Access Audit Site Reports

Atlanta State Park

Accessibility Evaluation

Inspection Date: 04/05/2022

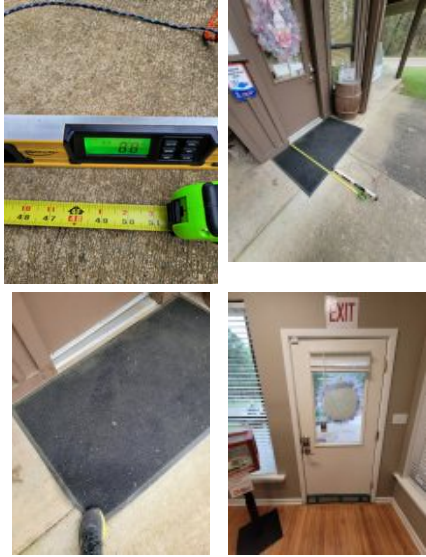
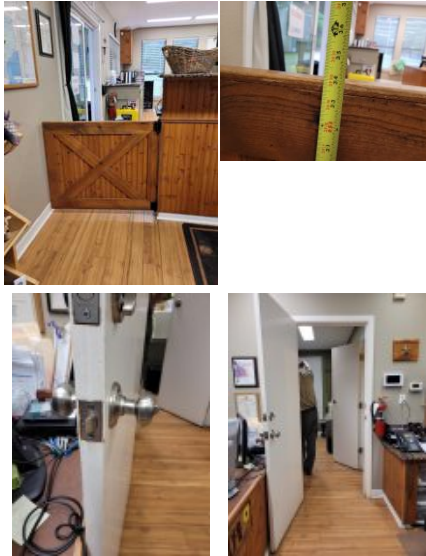
5	Headquarters Area: HQ - Parking	[33.2308606, -94.2496967]	The van stall is missing a sign identifying it as a van accessible stall. Parking space identification signs shall include the International Symbol of Accessibility. Signs identifying van parking spaces shall contain the designation "van accessible."	Space lacks van sign	Add one van parking sign to one accessible stall and assure stall and access aisle are 11' and 5' or 8' and 8'	2015 ABAAS Section: 502.6 2012 TAS Section: 502.6 2010 ADAS Section: 502.6

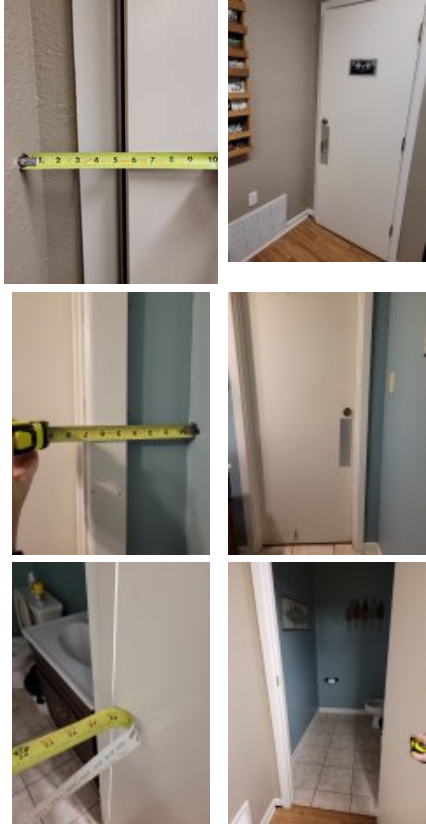
Finding Number	Area Description	Lat/Long	Finding	As Built	Recommendation	Citation	Photos	Figure
8	Headquarters Area: HQ - Exterior Accessible Route	[33.2307111 , -94.249753 3]	There is no accessible route to the ice machine At least one accessible route shall connect accessible buildings, accessible facilities, accessible elements, and accessible spaces that are on the same site.	Lacks AR to ice machine, 33.5" wide	Create an accessible route with crushed stone or other outdoor material from parking or walkway to the ice machine	2015 ABAAS Section: F206.2.2 2012 TAS Section: 206.2.2 2010 ADAS Section: 206.2.2		
9	Headquarters Area: HQ - Exterior Accessible Route	[33.2307731 , -94.249701 5]	The walkway contains abrupt vertical edges and/or variations over a 1/4 inch. 1/4 inch is the maximum vertical rise. Changes in level between 1/4 inch and 1/2 inch must be beveled at 1:2 or less. Changes in level greater than 1/2 inch must be by way of a ramp.	.5" near apparent ramp, .75" and .5" CIL on Route from parking to entry	Repair, bevel or ramp CIL along AR.	2012 TAS Section: 303.2, 303.3 2010 ADAS Section: 303.2, 303.3

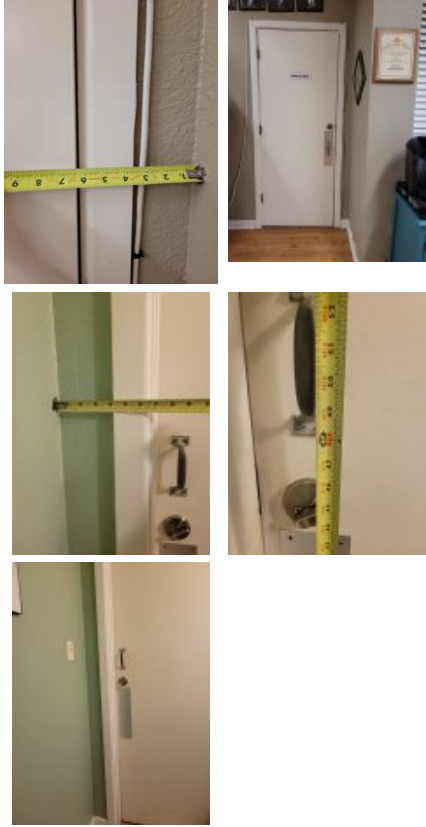
15	Headquarters Area: HQ - Public Spaces	[33.2307114, -94.2496444]	The walkway contains abrupt vertical edges and/or variations over a 1/4 inch. 1/4 inch is the maximum vertical rise. Changes in level between 1/4 inch and 1/2 inch must be beveled at 1:2 or less. Changes in level greater than 1/2 inch must be by way of a ramp.	no close AR to pay box, reach from road is 73" plus, you'd have to drive all the way around parking to get to ramp	Provide a curb ramp for access to the pay station.	2012 TAS Section: 303.2, 303.3 2010 ADAS Section: 303.2, 303.3

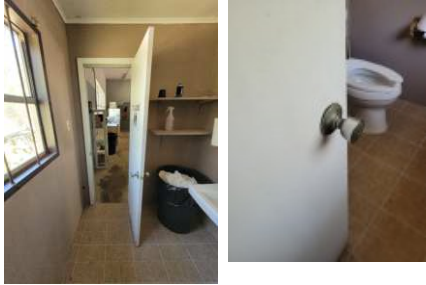
Finding Number	Area Description	Lat/Long	Finding	As Built	Recommendation	Citation	Photos	Figure
24	Employee Areas: Maintenance	[33.2338277 , -94.2498308]	There is no accessible route to the car ports. At least one accessible route shall connect accessible buildings, accessible facilities, accessible elements, and accessible spaces that are on the same site.	No accessible route (AR) to 2 of 2 exterior car ports	Create an accessible route with crushed stone or other outdoor material from parking or walkway to the car ports	2015 ABAAS Section: F206.2.2 2012 TAS Section: 206.2.2 2010 ADAS Section: 206.2.2		
25	Employee Areas: Maintenance	[33.2336942 , -94.2497544]	Spaces and elements within employee work areas shall only be required to comply with 206.2.8, 207.1, and 215.3 and shall be designed and constructed so that individuals with disabilities can approach, enter, and exit the employee work area. Employee work areas, or portions of employee work areas, other than raised courtroom stations, that are less than 300 square feet (28 m2) and elevated 7 inches (180 mm) or more above the finish floor or ground where the elevation is essential to the function of the space shall not be required to comply with these requirements or to be on an accessible route.	Shed office at maintenance- 12"CIL, knob, clearance on pull 3.5"	For employee spaces, relocate storage, furniture, and other obstacles at doorways to provide approach, enter and exit at the employee space.	2015 ABAAS Section: F203.9 2012 TAS Section: 203.9 2010 ADAS Section: 203.9

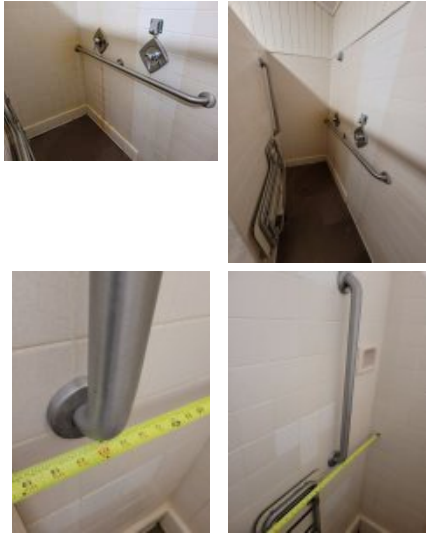
Finding Number	Area Description	Lat/Long	Finding	As Built	Recommendation	Citation	Photos	Figure
58	Knights Bluff Camping Area: Knights Bluff - Men's Restroom	[33.2351166 , -94.254185 4]	The shower seat does not have a compliant space between it and the wall. The folding seat must be mounted 17-19 inches above the floor, and have a maximum space of 1-1/2 inches between the edge of the seat and the side wall and 2-1/2 inches maximum to the seat wall.	Rear edge of seat 21.5" from wall, takes more than 5 LBF to operate	Remount shower seat to the correct location and height in the shower. Adjust seat so operating force is less than 5 LBF	2015 ABAAS Section: 610.3.2 2012 TAS Section: 610.3.2 2010 ADAS Section: 610.3.2		
59	Knights Bluff Camping Area: Knights Bluff - Men's Restroom	[33.2350537 , -94.254153 2]	The mirror is mounted too high. Mirrors must have the bottom edge of the reflecting surface a maximum of 40 inches above the floor if above a sink or counter. Mirrors not located above lavatories or countertops shall be installed with the bottom edge of the reflecting surface 35 inches maximum above the finish floor or ground.	0 of 2 mirrors complies, bottom of left mirror surface is 40.25" AFF, right mirror is 42" AFF	Raise one mirror so top of reflective surface is min. 74" AFF (and bottom of reflecting surface is max 40" AFF)	2015 ABAAS Section: 603.3 2012 TAS Section: 603.3 2010 ADAS Section: 603.3

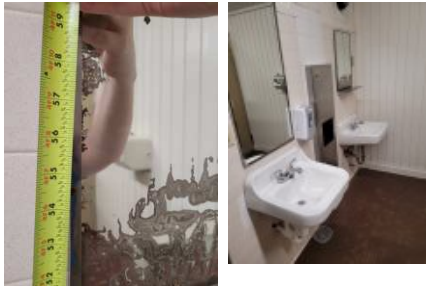
61	Knights Bluff Camping Area: Knights Bluff - Men's Restroom	[33.2350807 , -94.254206 8]	There are not enough accessible toilet compartments. The room contains toilet compartments. A minimum of 1 must be wheelchair accessible .	Lacks wheelchair accessible stall, ambulatory stall only	Create a wheelchair accessible stall with grab bars and fixtures mounted in correct locations and at correct heights.	2015 ABAAS Section: F213.3.1 2012 TAS Section: 213.3.1 2010 ADAS Section: 213.3.1

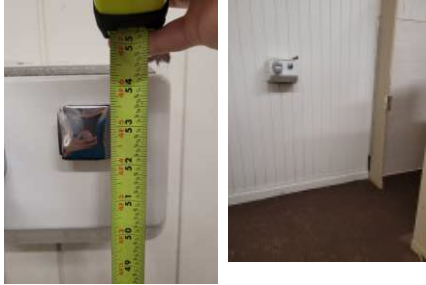
63	Knights Bluff Camping Area: Knights Bluff - Men's Restroom	[33.2351166 , -94.254217 6]	The ambulatory stall is not between 35" to 37" wide and 60" deep.	31" width	Correct ambulatory stall to be 35" to 37" wide and minimum 60" deep. In the alternative, use existing stall to create required wheelchair stall.	2015 ABAAS Section: 604.8.2.1 2012 TAS Section: 604.8.2.1 2010 ADAS Section: 604.8.2.1		
64	Knights Bluff Camping Area: Knights Bluff - Men's Restroom	[33.2351255 , -94.254185 4]	The grab bar height and/or spacing fails. Grab bars must be mounted between 33" and 36" to the top of the gripping surface. There must be 1.5" of clearance between the grab bar and the wall. There must be a minimum of 1.5" of clearance below and minimum 12" above the grab bar to any dispenser or other obstruction.	Both grab bars too high	Remount grab bars in accessible stall to 33" to 36" above the finished floor (AFF).	2015 ABAAS Section: 609.3, 609.4 2012 TAS Section: 609.4, 609.3 2010 ADAS Section: 609.3, 609.4

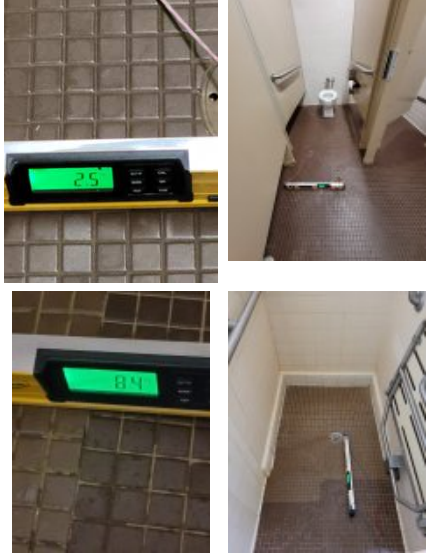
Finding Number	Area Description	Lat/Long	Finding	As Built	Recommendation	Citation	Photos	Figure
67	Knights Bluff Camping Area: Knights Bluff - Men's Restroom	[33.2350627 , -94.254174 7]	The accessible route contains running slopes greater than 5 percent and cross slopes greater than 2 percent across the width of the walk and has not been constructed as a ramp (i.e. handrails, wheel guides, etc.). When the slope in the direction of travel of any walk exceeds 1 unit vertical in 20 units horizontal (5-percent slope), it must be constructed as ramp. Surface cross slopes must not exceed one unit vertical in 48 units. Horizontal (2-percent slope).	2.9% cross slope at ambulatory stall	Correct or repair slope to max 2.08% in restroom.	2015 ABAAS Section: 403.3 2012 TAS Section: 403.3 2010 ADAS Section: 403.3		
68	Knights Bluff Camping Area: Knights Bluff - Women's Restroom	[33.2351143 , -94.254193 4]	Coat hooks provided within the room shall be located within one of the reach ranges specified in 308. Where coat hooks or shelves are provided in dressing, fitting or locker rooms without individual compartments, at least one of each type shall comply with 803.5. Where coat hooks or shelves are provided in individual compartments at least one of each type complying with 803.5 shall be provided in individual compartments in dressing, fitting, or locker rooms required to comply with 222.1.	Hooks 67" AFF	Remount at least one hook to max 48" AFF	2015 ABAAS Section: 308.2.1, 308.1, F222.2, 803.5 2012 TAS Section: 308.2.1, 308.1, 222.2, 803.5 2010 ADAS Section: 308.2.1, 308.1, 222.2, 803.5

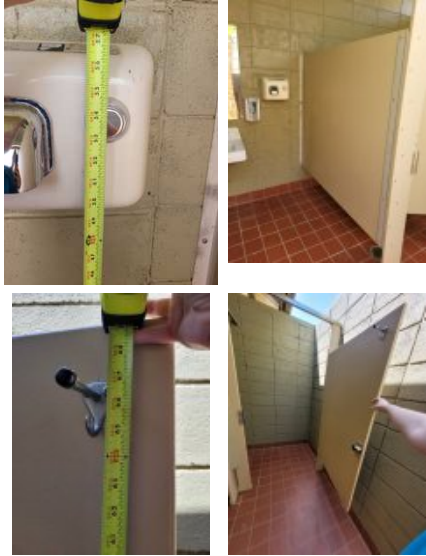
Finding Number	Area Description	Lat/Long	Finding	As Built	Recommendation	Citation	Photos	Figure
94	Day Use Area: Day Use - Picnic Area	[33.2372299 , -94.255499 7]	The surface of outdoor recreation access routes, passing spaces, and resting intervals shall be firm and stable	No route to 11 of 11 grills, 4 of 4 spouts, 24 of 24 picnic tables at day use; 0 of accessible design	Repair or replace surface or ORAR to be firm and stable as a smart practice. Provide route to 3 grills and tables. Replace 5 tables with ones of an accessible design.	2015 ABAAS Section: 1016. 2		
95	Day Use Area: Day Use - Men's Restroom	[33.2379108 , -94.255250 2]	The restroom sign does not comply with one or more applicable requirements for the location, height, and properties of the sign.	Restroom lacks accessible signage	Acquire and mount signage, including Braille, raised lettering and access symbol mounted on wall, latch side of gate, 48" to baseline of lowest character and 60" to baseline of highest character	2015 ABAAS Section: F216.2, 703.1, 703.2, 703.5, 703.6 2012 TAS Section: 216.2, 703.1, 703.2, 703.5, 703.6 2010 ADAS Section: 216.2, 703.1, 703.2, 703.5, 703.6

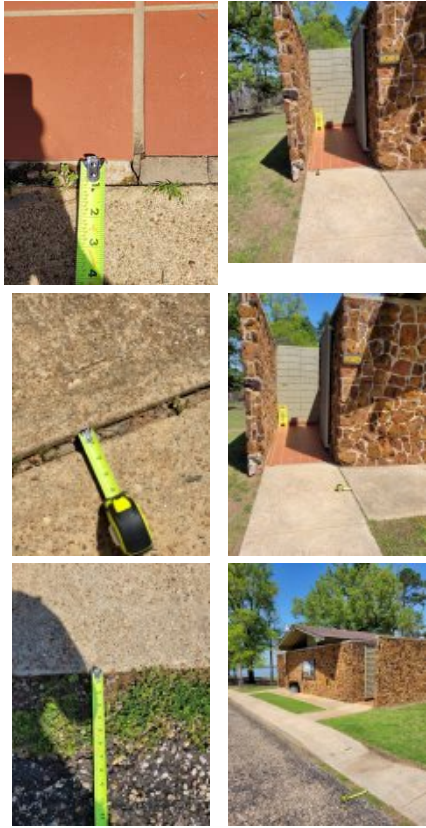
102	Day Use Area: Day Use - Men's Restroom	[33.237904, -94.2552422]	The grab bar height and/or spacing fails. Grab bars must be mounted between 33" and 36" to the top of the gripping surface. There must be 1.5" of clearance between the grab bar and the wall. There must be a minimum of 1.5" of clearance below and minimum 12" above the grab bar to any dispenser or other obstruction.	Right grab bar, 36.5" AFF to top	Remount grab bars in accessible stall to 33" to 36" above the finished floor (AFF).	2015 ABAAS Section: 609.3, 609.4 2012 TAS Section: 609.4, 609.3 2010 ADAS Section: 609.3, 609.4

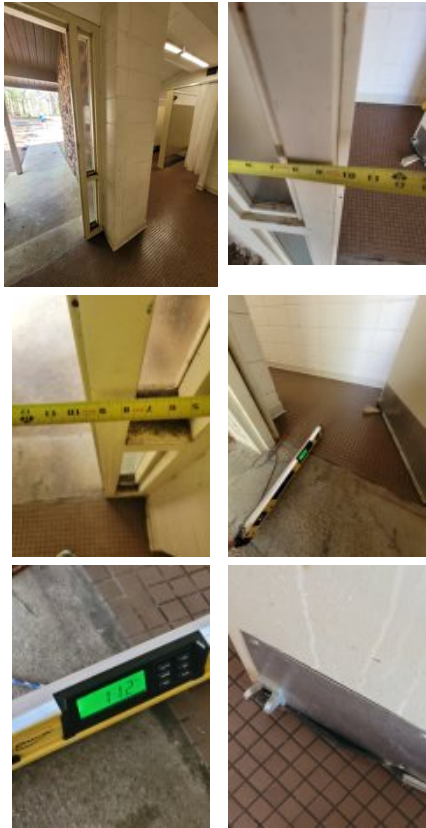
Finding Number	Area Description	Lat/Long	Finding	As Built	Recommendation	Citation	Photos	Figure
118	Day Use Area: Day Use - Playground and Beach Access	[33.2378513 , -94.255092]	There is no accessible route within the play area At least one accessible route shall connect accessible buildings, accessible facilities, accessible elements, and accessible spaces that are on the same site.	Swing area surface is pea gravel	Replace surface at swings with one that is firm and stable.	2015 ABAAS Section: F206.2.2 2012 TAS Section: 206.2.2 2010 ADAS Section: 206.2.2		
119	Day Use Area: Day Use - Playground and Beach Access	[33.2391278 , -94.255784]	Beach access routes shall connect an entry point to the beach to the: 1. High tide level at tidal beaches; 2. Mean high water level at river beaches; or 3. Normal recreation water level at lake, pond, and reservoir beaches	No AR to beach	Create a beach access route to normal recreational water level of a firm and stable material as a smart practice	2015 ABAAS Section: 1018.2

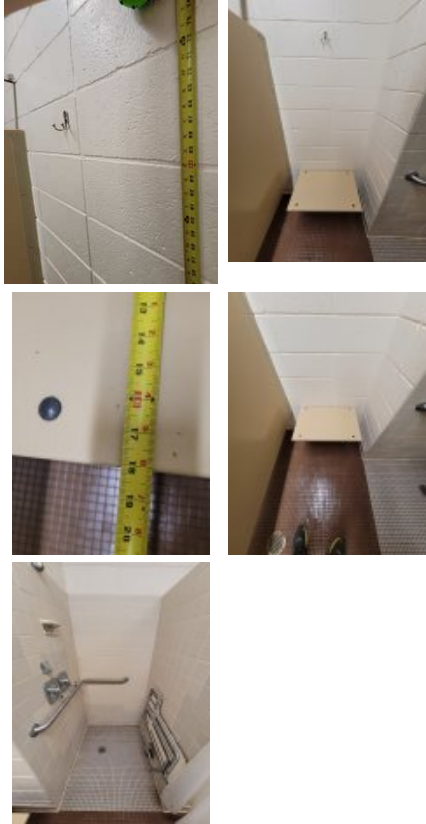
Finding Number	Area Description	Lat/Long	Finding	As Built	Recommendation	Citation	Photos	Figure
127	Wilkins Creek Camping Area: Wilkins Creek - Parking and Exterior Accessible Route at Restrooms	[33.2297949 , -94.2360671]	The cross slopes (narrow dimension) and/or running slopes (long dimension) of the access aisle exceeds 2%. The running slope and the cross slope in an accessible parking stall and the access aisle must not exceed 2%.	Stall - 2.5% slope, probable access aisle - 2.4% and 5.6% slope	Repair or correct slope of parking space and access aisle to max 2.08% in any direction.	2015 ABAAS Section: 502.4 2012 TAS Section: 502.4 2010 ADAS Section: 502.4

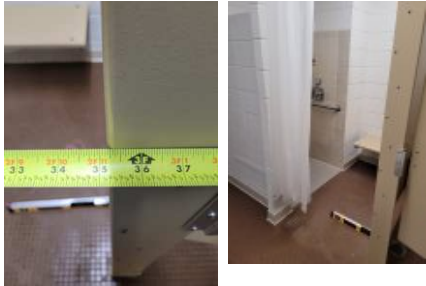
142	Wilkins Creek Camping Area: Wilkins Creek - Men's Restroom	[33.2297657 , -94.2361207]	Transfer type shower compartments shall be 36 inches (915 mm) by 36 inches (915 mm) clear inside dimensions measured at the center points of opposing sides and shall have a 36 inch (915 mm) wide minimum entry on the face of the shower compartment. Clearance of 36 inches (915 mm) wide minimum by 48 inches (1220 mm) long minimum measured from the control wall shall be provided.	Stall 39" wide, 43.5" deep	Reduce transfer shower to compliant 36" by 36" clear inside dimension	2015 ABAAS Section: 608.2.1 2012 TAS Section: 608.2.1 2010 ADAS Section: 608.2.1

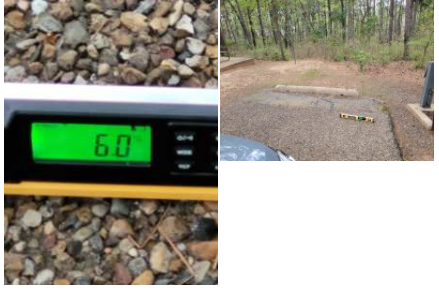
Finding Number	Area Description	Lat/Long	Finding	As Built	Recommendation	Citation	Photos	Figure
156	Wilkins Creek Camping Area: Wilkins Creek - Women's Restroom	[33.2297679 , -94.236134 1]	Transfer type shower compartments shall be 36 inches (915 mm) by 36 inches (915 mm) clear inside dimensions measured at the center points of opposing sides and shall have a 36 inch (915 mm) wide minimum entry on the face of the shower compartment. Clearance of 36 inches (915 mm) wide minimum by 48 inches (1220 mm) long minimum measured from the control wall shall be provided.	shower dimension - 43.5" depth by 39" width	Reduce transfer shower to compliant 36" by 36" clear inside dimension	2015 ABAAS Section: 608.2.1 2012 TAS Section: 608.2.1 2010 ADAS Section: 608.2.1		 <p><small>Note: Inside finished dimensions measured at the center points of opposing sides.</small></p>
157	Wilkins Creek Camping Area: Wilkins Creek - Women's Restroom	[33.2297702 , -94.236126 1]	Transfer type shower compartments shall be 36 inches (915 mm) by 36 inches (915 mm) clear inside dimensions measured at the center points of opposing sides and shall have a 36 inch (915 mm) wide minimum entry on the face of the shower compartment. Clearance of 36 inches (915 mm) wide minimum by 48 inches (1220 mm) long minimum measured from the control wall shall be provided.	35.5" width at entry	Provide appropriate CFS on the exterior of the transfer shower.	2015 ABAAS Section: 608.2.1 2012 TAS Section: 608.2.1 2010 ADAS Section: 608.2.1		 <p><small>Note: Inside finished dimensions measured at the center points of opposing sides.</small></p>

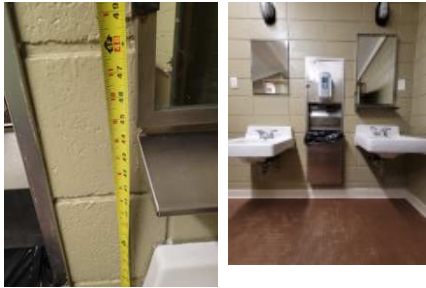
Finding Number	Area Description	Lat/Long	Finding	As Built	Recommendation	Citation	Photos	Figure
160	Wilkins Creek Camping Area: Wilkins Creek - Women's Restroom	[33.2297702 , -94.236126 1]	The accessible route contains slopes greater than 2 percent across the width of the walk and has not been constructed as a ramp (i.e. handrails, wheel guides, etc.). Surface cross slopes must not exceed one unit vertical in 48 units. Horizontal (2-percent slope).	4.2% within shower	Correct or repair slope to max 2.08% in restroom.	2015 ABAAS Section: 403.3 2012 TAS Section: 403.3 2010 ADAS Section: 403.3	 	
161	Wilkins Creek Camping Area: Wilkins Creek - Women's Restroom	[33.2297702 , -94.236123 4]	Minimum maneuvering clearances at doors and gates shall comply with 404.2.4. Maneuvering clearances shall extend the full width of the doorway and the required latch side or hinge side clearance. Maneuvering clearances shall have a max slope of 2.08%. Exterior doors are recommended to be maintained at 8.5 lbf as a smart practice. Force is to be measured at the operating hardware or 30 inches from the hinges, whichever is greater.	Door - wall obstructs back clearance, 15# push, 7.4% slope in clearance, 9.5" to wall on pull side	For all doors along the public circulation route, provide required maneuvering clearance on push and pull side of doors. For all doors along the public circulation route, correct slope in door clearance to max 2.08%. For all doors along the public circulation route, inspect, adjust, and maintain 8.5 lbf to open exterior doors as a smart practice.	2010 ADAS Section: 404.2.3, 404.2.7, 404.2.4, 404.2.11, 404.2.11 Exception

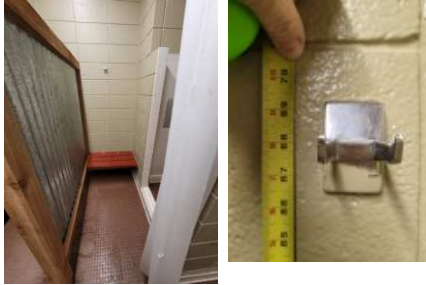
Finding Number	Area Description	Lat/Long	Finding	As Built	Recommendation	Citation	Photos	Figure
169	White Oak Camping Area: White Oak - Men's Restroom	[33.2341148 , -94.235274 5]	The accessible route of travel contains cross slopes greater than 2%. Cross slopes shall not exceed one unit vertical in 48 units horizontal (2-percent slope).	4.5% cross slope at AR to men's restroom	Correct or repair cross slope along AR to max 2.08%.	2015 ABAAS Section: 403.3 2012 TAS Section: 403.3 2010 ADAS Section: 403.3	 	
170	White Oak Camping Area: White Oak - Men's Restroom	[33.234089, -94.235270 4]	Minimum maneuvering clearances at doors and gates shall comply with 404.2.4. Maneuvering clearances shall extend the full width of the doorway and the required latch side or hinge side clearance. Maneuvering clearances shall have a max slope of 2.08%. The threshold has a gap greater than 1/2 inch wide. Exterior doors are recommended to be maintained at 8.5 lbf as a smart practice. Force is to be measured at the operating hardware or 30 inches from the hinges, whichever is greater.	Door - stone wall in pull side clearance, wall in push side clearance, 7.4% slope pull side, 1" gap pull side, 10# push	For all doors along the public circulation route, provide required maneuvering clearance on push and pull side of doors. For all doors along the public circulation route, correct slope in door clearance to max 2.08%. For all doors along the public circulation route, fill gaps at door entries to max .5". For all doors along the public circulation route, inspect, adjust, and maintain 8.5 lbf to open exterior doors as a smart practice.	2010 ADAS Section: 404.2.3, 404.2.7, 404.2.4, 404.2.11, 404.2.11 Exception

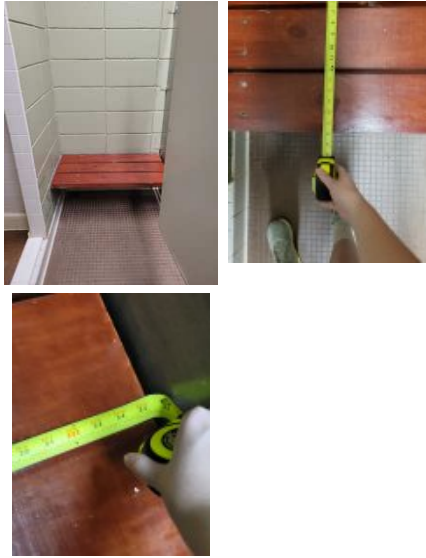
Finding Number	Area Description	Lat/Long	Finding	As Built	Recommendation	Citation	Photos	Figure
174	White Oak Camping Area: White Oak - Men's Restroom	[33.2341047 , -94.2352718]	The water and drain pipes under the lavatory are not adequately insulated. Water supply and drain pipes under lavatories and sinks shall be insulated or otherwise configured to protect against contact. There shall be no sharp or abrasive surfaces under lavatories and sinks.	Pipes lack insulation	Insulate exposed pipes under one sink.	2015 ABAAS Section: 606.5 2012 TAS Section: 606.5 2010 ADAS Section: 606.5		
175	White Oak Camping Area: White Oak - Men's Restroom	[33.2341025 , -94.2352691]	Where a high forward reach is over an obstruction, the clear floor space shall extend beneath the element for a distance not less than the required reach depth over the obstruction. The high forward reach shall be 48 inches (1220 mm) maximum where the reach depth is 20 inches (510 mm) maximum. Where the reach depth exceeds 20 inches (510 mm), the high forward reach shall be 44 inches (1120 mm) maximum and the reach depth shall be 25 inches (635 mm) maximum. Where a clear floor or ground space allows a parallel approach to an element and the high side reach is over an obstruction, the height of the obstruction shall be 34 inches (865 mm) maximum and the depth of the obstruction shall be 24 inches (610 mm) maximum. The high side reach shall be 48 inches (1220 mm) maximum for a reach depth of 10 inches (255 mm) maximum. Where the reach depth exceeds 10 inches (255 mm), the high side reach shall be 46 inches (1170 mm) maximum for a reach depth of 24 inches (610 mm) maximum.	66" AFF to hook, 46" AFF to obstructed soap dispenser, 56" AFF to dryer,	Lower hook and hand dryer to max 48" above the finished floor (AFF) to highest operable part. Lower soap dispenser to max 44" above the finished floor (AFF) for a forward reach over counter.	2015 ABAAS Section: 308.2.1, 308.3.2 2012 TAS Section: 308.2.1, 308.3.2 2010 ADAS Section: 308.2.1, 308.3.2
